TEAC TECHNICAL INFORMATION

9513

TASCAM CD-701, Open/Close Button

This information is a revised edition of Technical Information No. 9105.

Drawing below shows how to mount the new Open/Close Button.

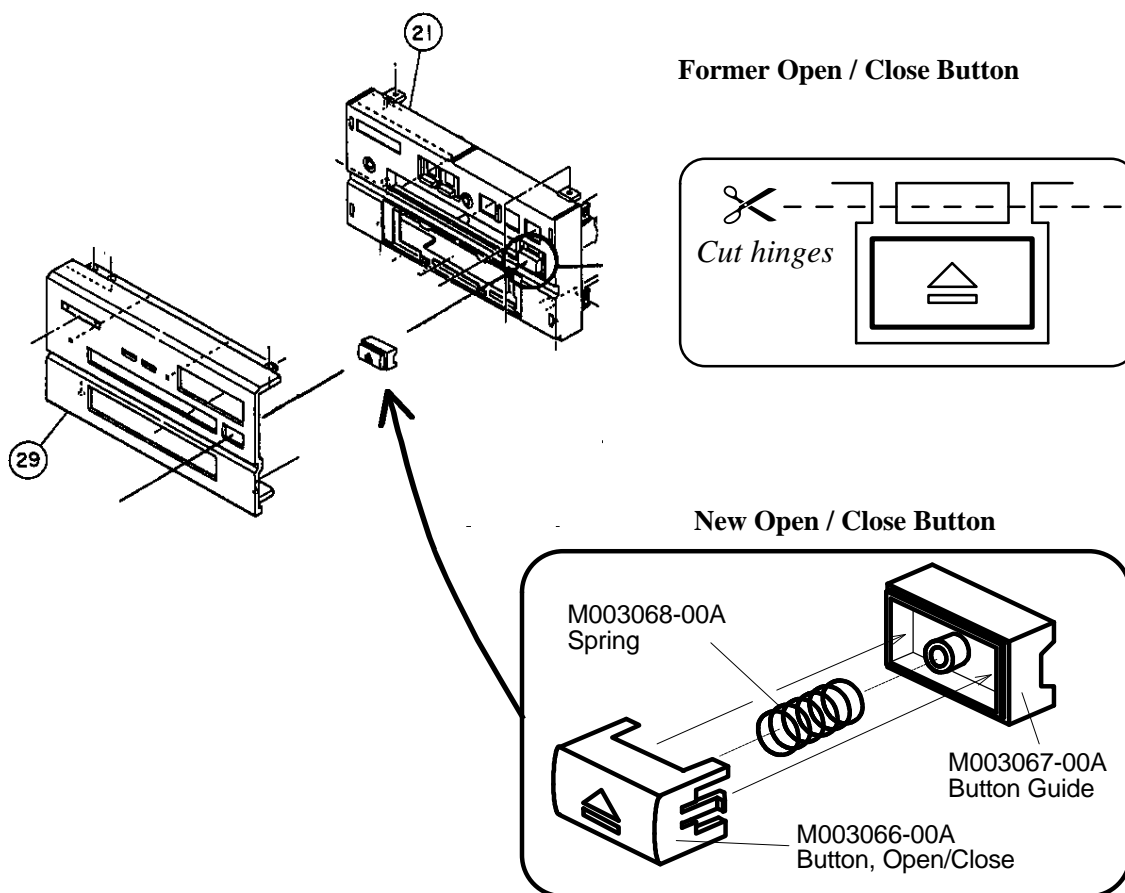
In order to improve durability, make of the Open/Close Button has been changed on the products serial numbered 400001 and up.

- 1 Cut off former button from Panel, Front (Ref 1-21).
- 2 Assemble new button and put it between Panel, Front(Ref 1-21) and Panel, Dress(Ref 1-29).
